DATE: 03.27.2019
TO: ProTrak
FROM: Mitesh Baxi
Traffic Engineering

■ **CREEKSIDE [TRC Plan Review]**

↻ Initial Review Note ↻

SITE PLAN
 CREEKSIDE
 MASONBORO SOUND RD.
 WILMINGTON, NC, NEW HANOVER COUNTY

Creekside Subdivision Standard Street Lighting Plan

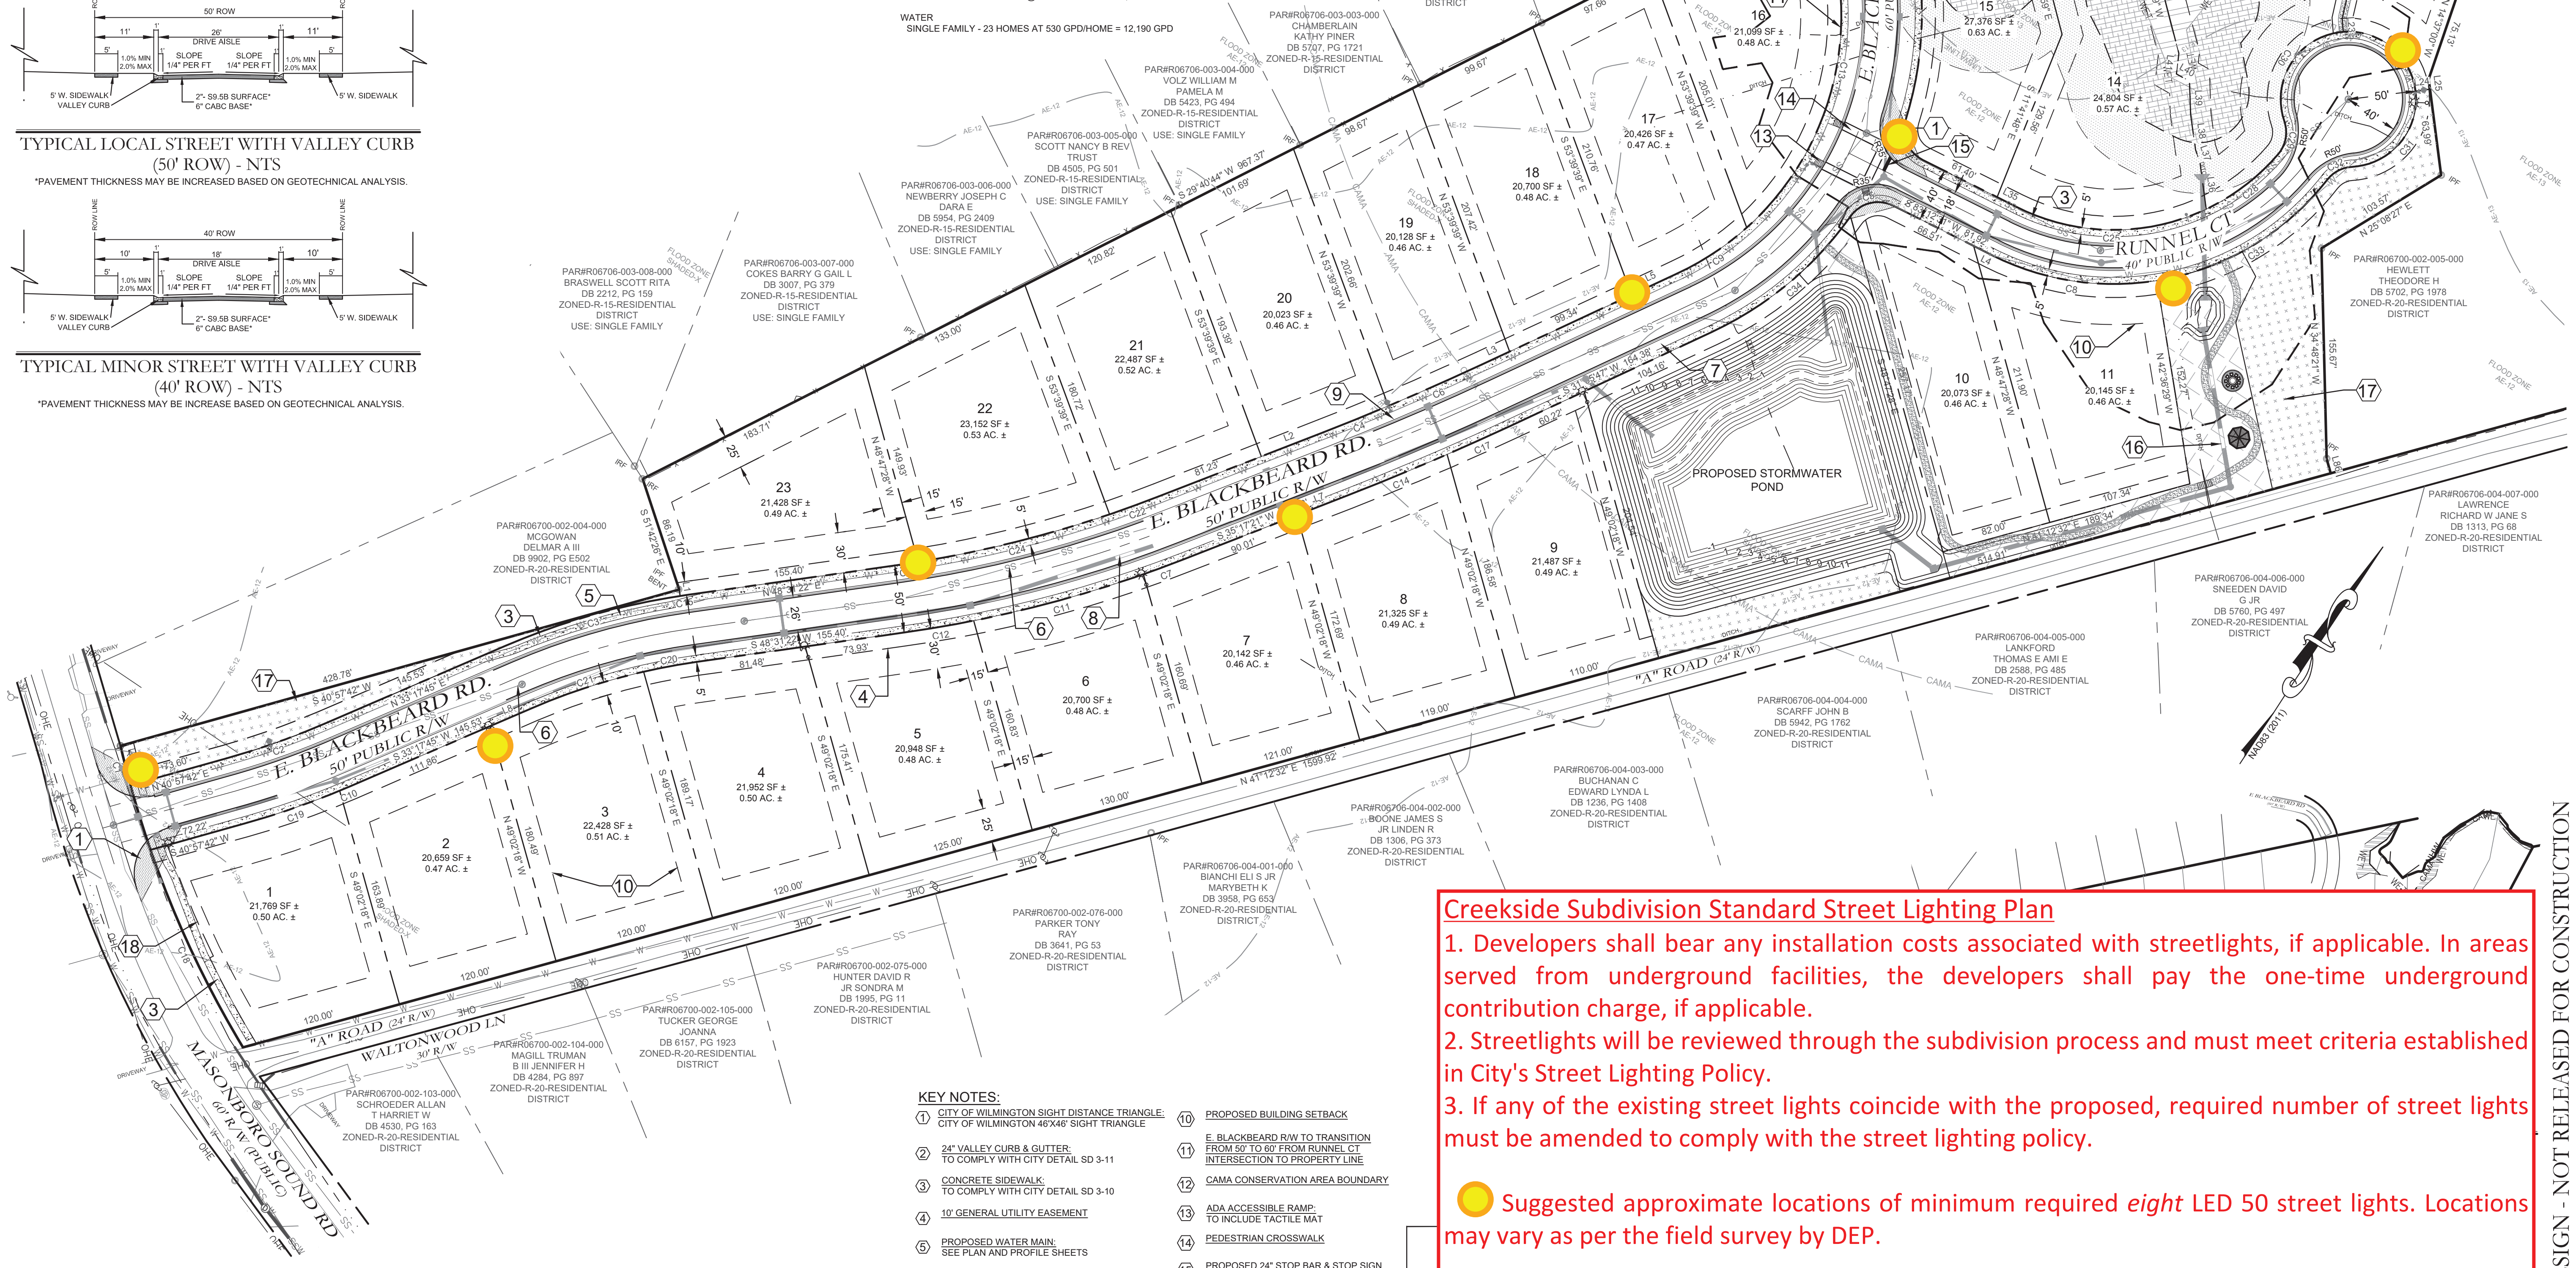
2. A layout for the Standard street lighting has been provided with the review. Minimum of 8 (eight) street lights are required for this sub-division. Although, developers may choose to provide any extra lights or ornamental. Any installations above the criteria of Standard street lighting, will be considered as non-standard and has to conform to the City's non-standard street lighting procedure as per the policy.

● Suggested approximate locations of minimum required eight LED 50 street lights. Locations may vary as per the field survey by DEP.
